From: Palla, Robert
Sent: Thursday, October 29, 2009 1:07 PM
To: Stuyvenberg, Andrew
Cc: IPRenewal NPEmails
Subject: Weather Runs 10 29 09.doc
Attachments: Weather Runs 10 29 09.doc

Indian Point Weather

Figure 1. Plot of Entergy 5 Year Averaged Weather from the site 10 meter tower showing direction wind is blowing toward.

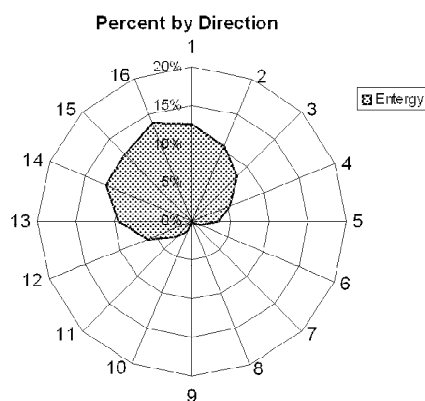
predominantly in the northerly direction as shown in Figure 1. Review of the process describing how the weather was averaged did not provide insights into why the wind rose is predominantly northerly.

Figure 2. Plot of Weather for Years 1999 – 2002 from the site 10 meter tower showing direction wind is blowing toward. (percent by direction)

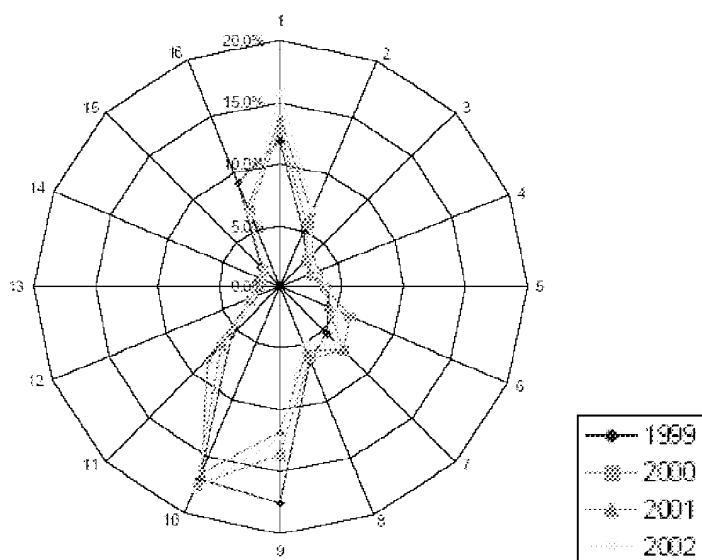
information provided in the Indian Point annual effluent reports for 1999 through 2002 (ML031220099, ML021260723, ML011240172, ML003714664), also for the 10 meter met tower. A wind rose was developed for each year from 1999 through 2002. Each of the weather files for the years 1999 thru 2002 are relatively similar, and the wind rose for each year of weather shows in Figure 2 that the northern and southern directions are

dominant. Thus, the MACCS2 input of averaged weather used in the analysis does not appear to reflect the annual weather conditions. An analysis is needed using discrete years of weather data for each or at least some of the 5 years, without averaging weather, to understand the effects of weather on the SAMA conclusions.

1. Additional information is needed in the form of consequence analyses using annual, rather than averaged, weather data. An analysis of at least one specific weather year should be conducted using the 10 meter weather information available from the site. Use of the 10 meter station may be expected to show a greater likelihood of wind in the northerly and southerly directions following the river. It may be beneficial to also perform an analysis using the weather data from the 120 meter station available from the site.
